Staff Report

To: Salt Lake City Planning Commission
From: Wayne Mills, Planning Manager, wayne.mills@slcgov.com, 801-718-9431
Date: May 11, 2022
Re: PLNSUB2017-01027 – Modification to Lot 2 of the Sugar House Heights Planned Development

Planned Development Modification

PROPERTY ADDRESS: 2660 S. Highland Drive

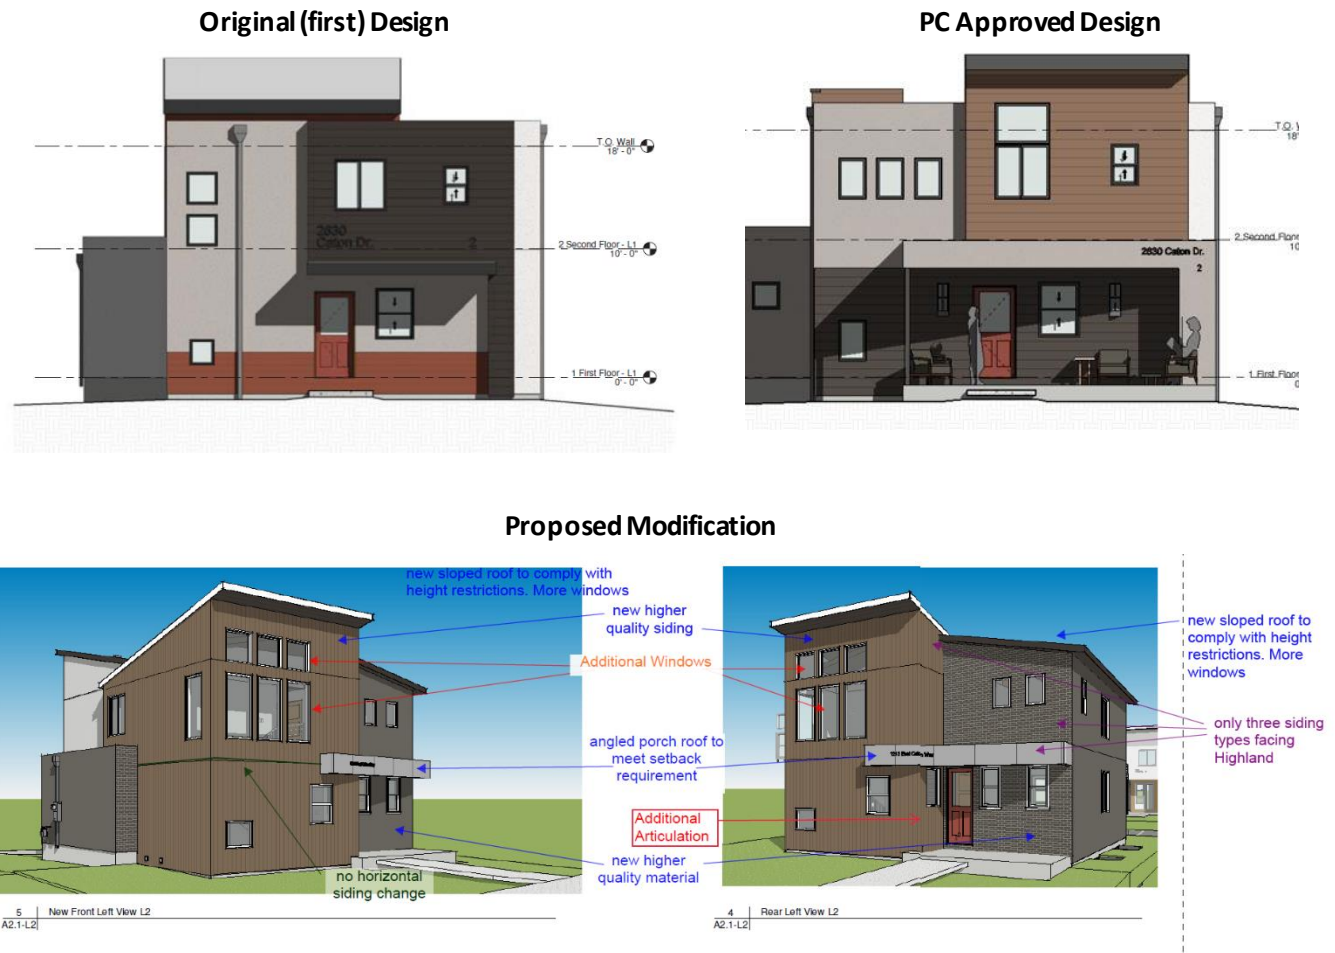
The applicant returned to the PC on September 26, 2018 with revised plans for the homes on lots one and two. The report to the PC can be found here - <http://www.slcdocs.com/Planning/Planning%20Commission/2018/0102701028Memo.pdf> and the recording of the meeting can be found here - <https://www.youtube.com/watch?v=vU8tVv8etio&t=1995s> (item begins at 10 min. 10 sec.). The report to the Planning Commission highlighted the following changes to the design:

- Added a pitched roof form
- Added a semi-enclosed porch with slab on grade
- Altered window configuration
- Increased use of wood siding
- Added lighting fixtures

Site Plan Approve by PC

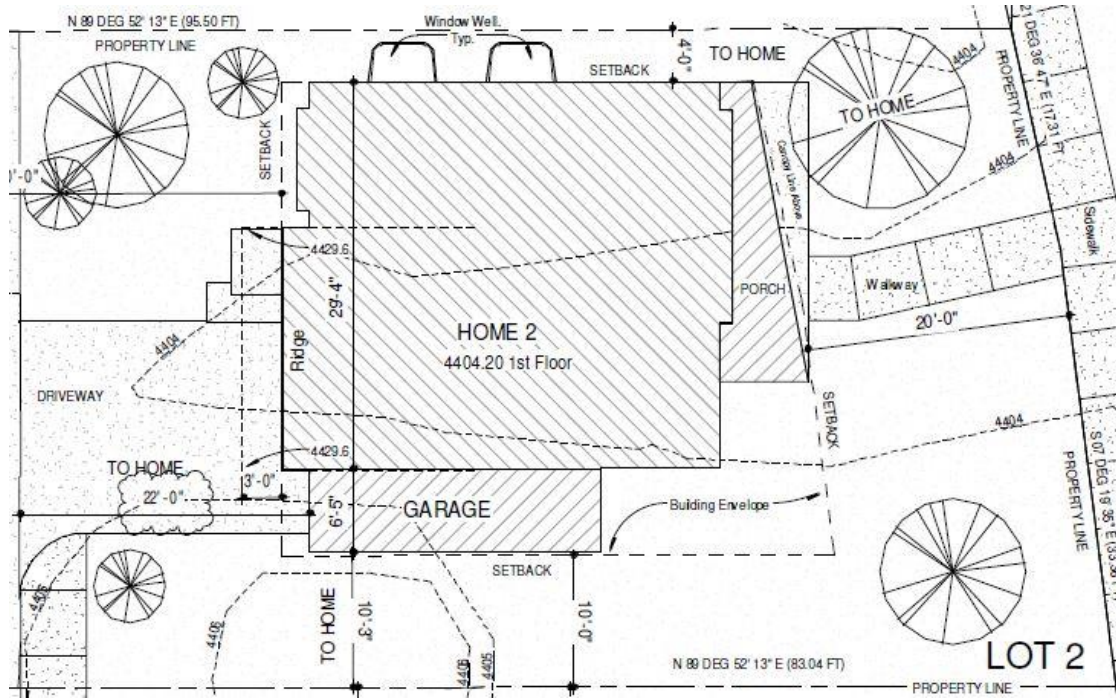
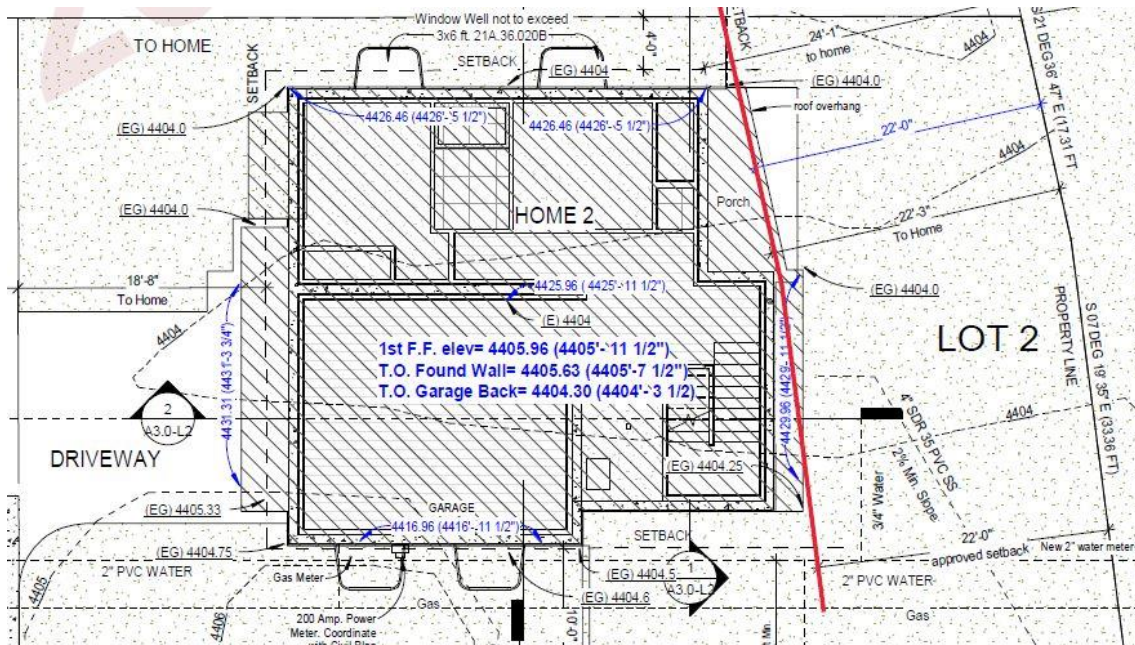
When comparing the plans submitted for PC approval in 2018 against the plan submitted for building permits, it appears that a mistake was made on the approved plans in relation to the required front yard setback. The site plan that was provided when the project was submitted to the PC for a decision shows a front yard setback of 20 feet. This was an incorrect dimension, and the home was designed according to that incorrect dimension. The staff report initially submitted to the PC (<http://www.slcdocs.com/Planning/Planning%20Commission/2018/SugarHouseHeightsSR.pdf>) stated that the required front yard setback is 22 feet where the plan submitted for final decision showed a front yard setback of 20 feet. The PC did not approve a change in the required front yard setback; therefore, the home should have been designed with a 22-foot front yard setback. The proposed design modification meets the 22-foot front yard setback requirement. In order to modify the front yard requirement, a new Planned Development application would be required. The following diagrams show the site plan that was submitted to the PC when the project was presented for a decision followed by the site plan associated with the proposed modification.

Proposed Modification Site Plan

1	Site Plan - L2
A0.0-L2	1/8" = 1'-0"

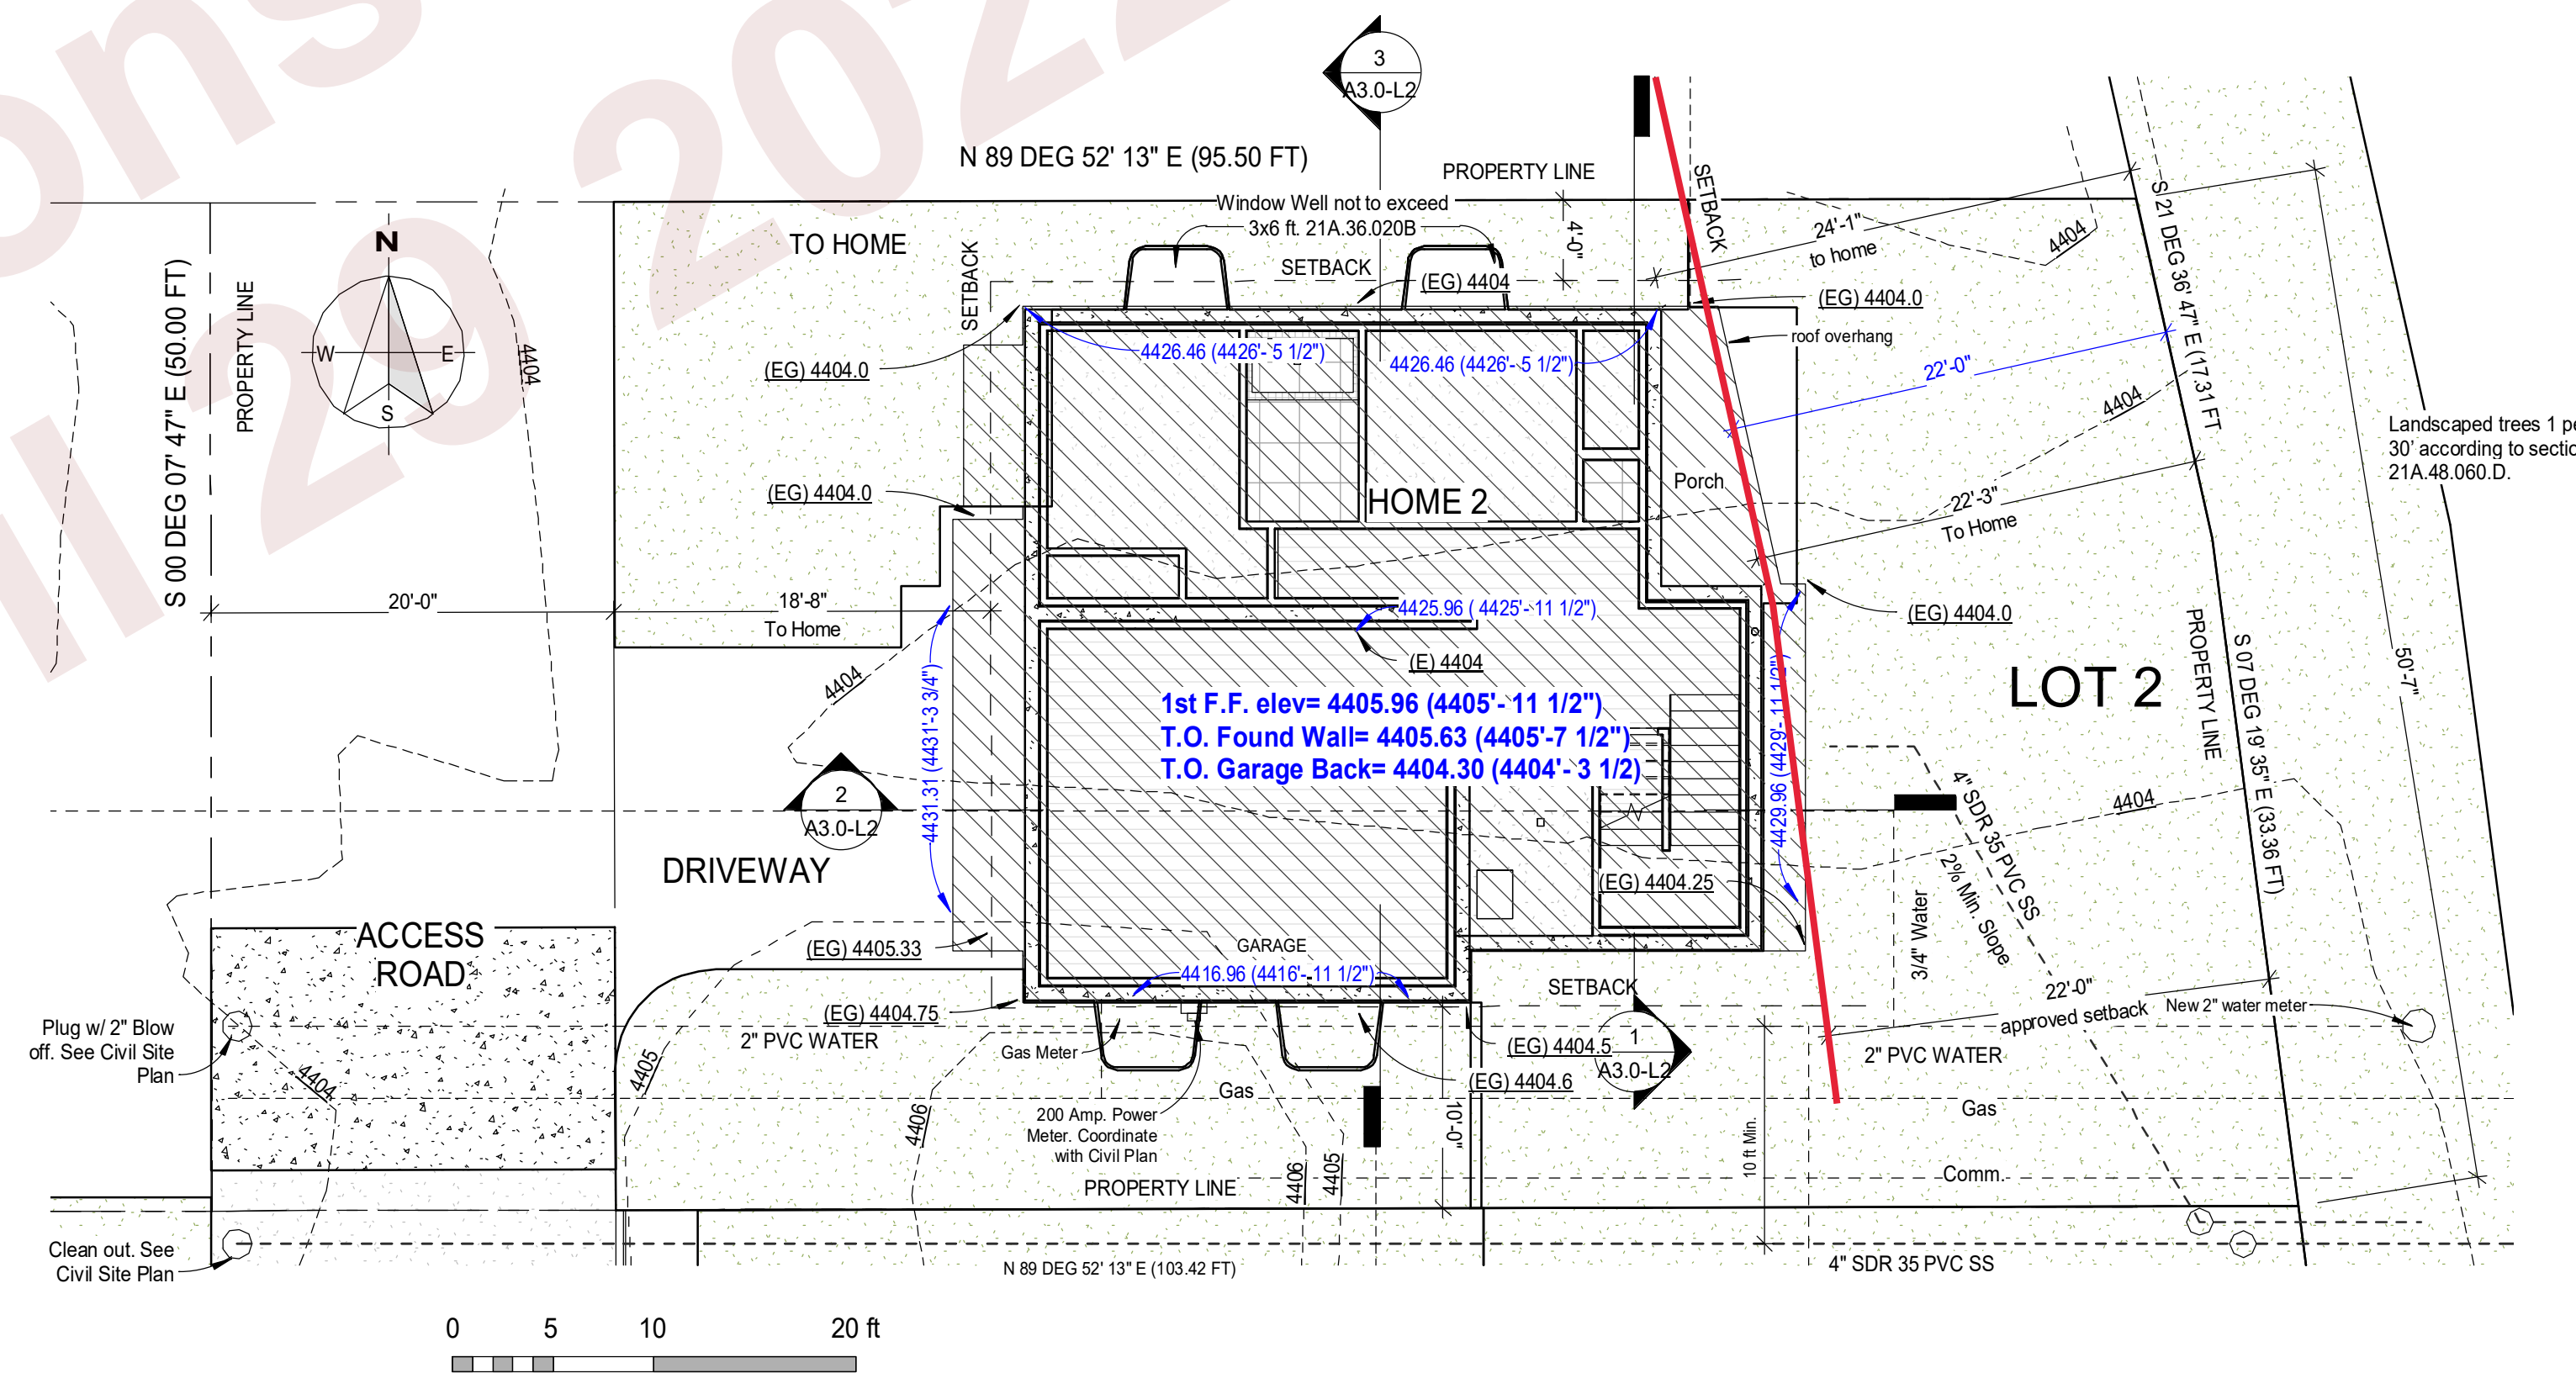
We'd like to submit this new version of the plan for lot 2 in our Sugarhouse Heights subdivision. In order to meet the height and setback requirements some changes were made from the version previously approved. You'll see a red line on the site plan showing the setback where the porch cover had to be reduced to line up with the setback distance. Because of the 20' height restriction with a flat roof we pitched the roof while keeping the modern look. This allowed us to have more windows in the front upper level facade. We tried to keep with the guidance previously given to the previous developer/architect when it was in concept stage but I don't believe they understood the setback on this lot so their porch encroached into the setback.

The following is in response to comments from Salt Lake City regarding the required front yard setback of lot 2 in the Sugarhouse Heights Subdivision.

- **Front Yard Averaging Requirement:** Pursuant to SLC code 21A.24.070.E. In reviewing the staff report for the approved Development Plan with file with the Salt Lake City Planning Division under petition PLNSUB2017-01027, the following information was provided regarding the front yard averaging.
- As found on page 46 of the staff report,
- Per definition, lots 1 and 2 have front yards that abut Highland Drive, the public street. The average of the front yards of the existing buildings within the block face is approximately 22 feet. The submitted plans indicate that all four (4) proposed front yards have front yards of at least 22 feet. They are approximately as follows:*
- Lot 1: 30 feet*
 - Lot 2: 22 feet*
 - Lot 3: 22 feet*
 - Lot 4: 42 feet (includes width of drive)*

ATTACHMENT C: Highland Drive Design Comparison

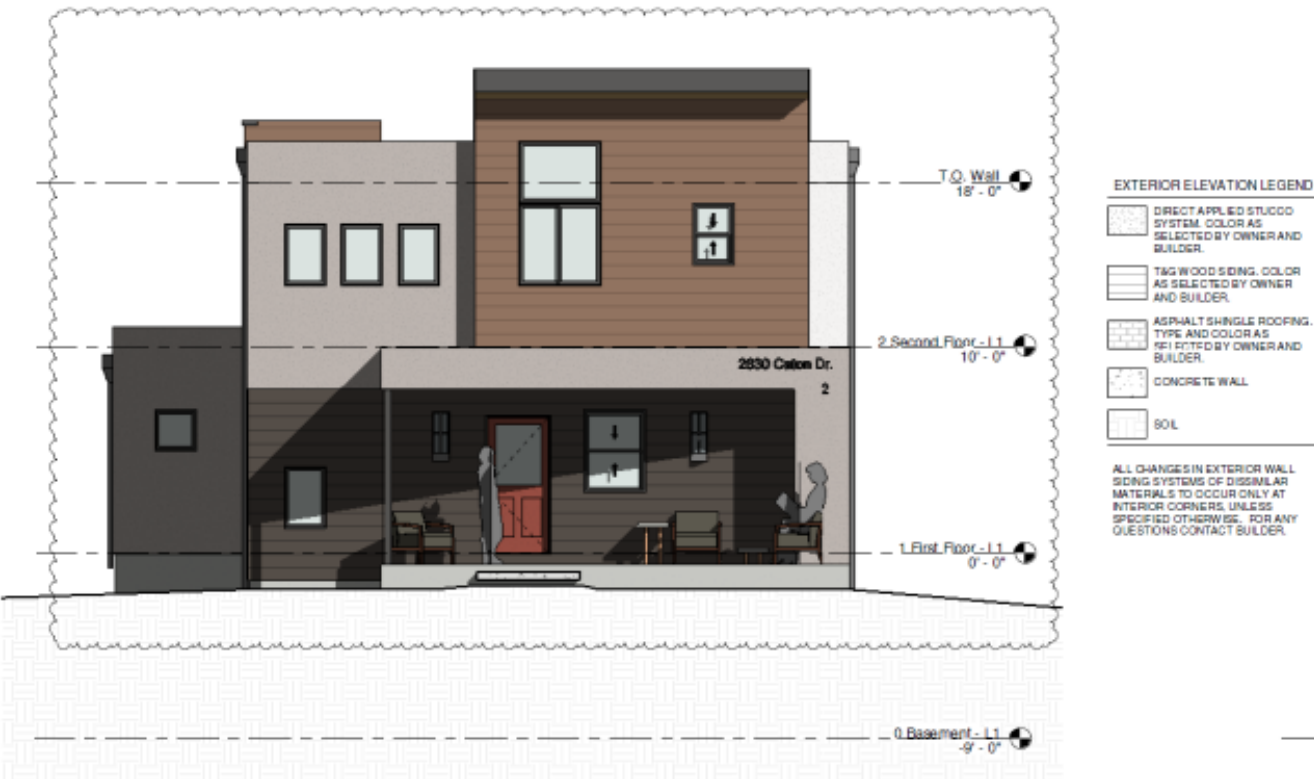
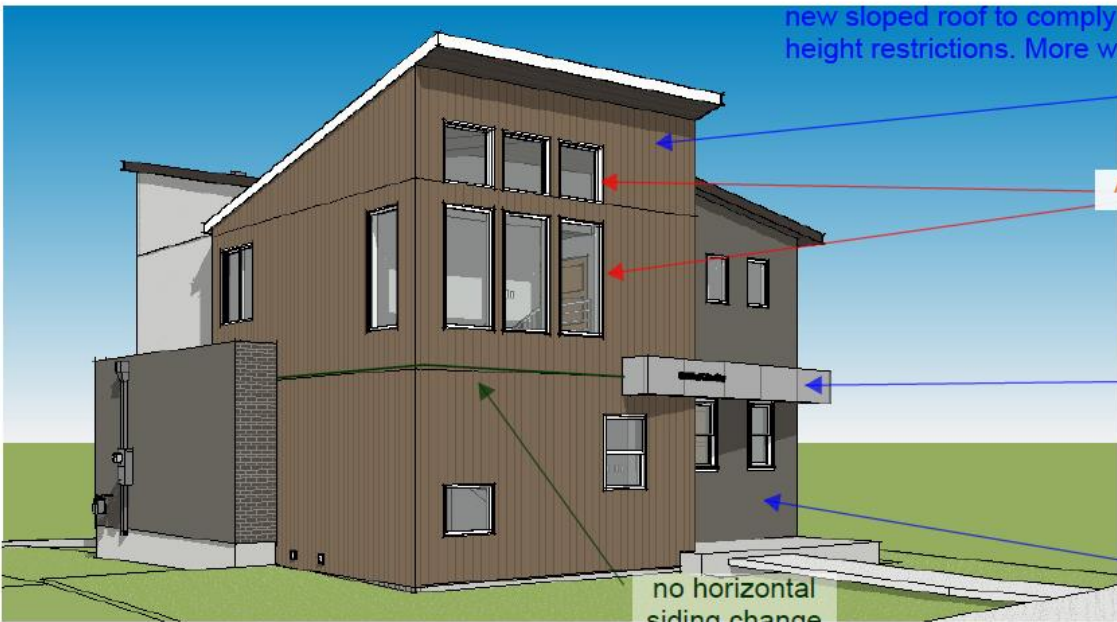
When comparing the proposed design against the design approved by the PC, it is Staff’s opinion that the Design approved by PC better meets the items required by the PC when they tabled their decision; however, the applicant has stated that there are constraints with the design that was presented to the Planning Commission. Upon further development of the building plans, it was determined that the home approved by the PC was designed with an incorrect front yard setback and the same design could not meet zoning regulations and still be functional. Considering this issue, the proposed design should be reviewed according to the original motion made by the PC to determine if it *“includes features typically found on the front façade of a single-family home...”* The following is Staff’s opinion regarding the conformance of the new design:

1. *Enhanced entryways with useable porch features;*
Staff Opinion: There is a useable porch and the entryway is an enhancement over the original (first) design.

2. *Prominent front entry doors;*
Staff Opinion: There is a front entry door that is consistent with front entry doors of single-family homes.
3. *Window patterns/configurations that are more appropriate for a prominent, street-facing façade;*
Staff Opinion: The second story windows provide a prominent feature to the street-facing façade.
4. *Use of more articulation in the building wall and/or additional building materials to increase visual interest.*
Staff Opinion: Façade is broken up by different building materials and the porch overhang adds articulation.
5. *Roof detailing that would be more consistent with the front of a home.*
Staff Opinion: Roof detailing is consistent with the front of a home and is an enhancement over the original (first) design.

It is Staff's opinion that the proposed design is consistent with the PC's requirement of including architectural features typically found on the front façade of a single-family home and is in substantial conformity with the approved development plan; therefore, Staff recommends that the PC approve the request.
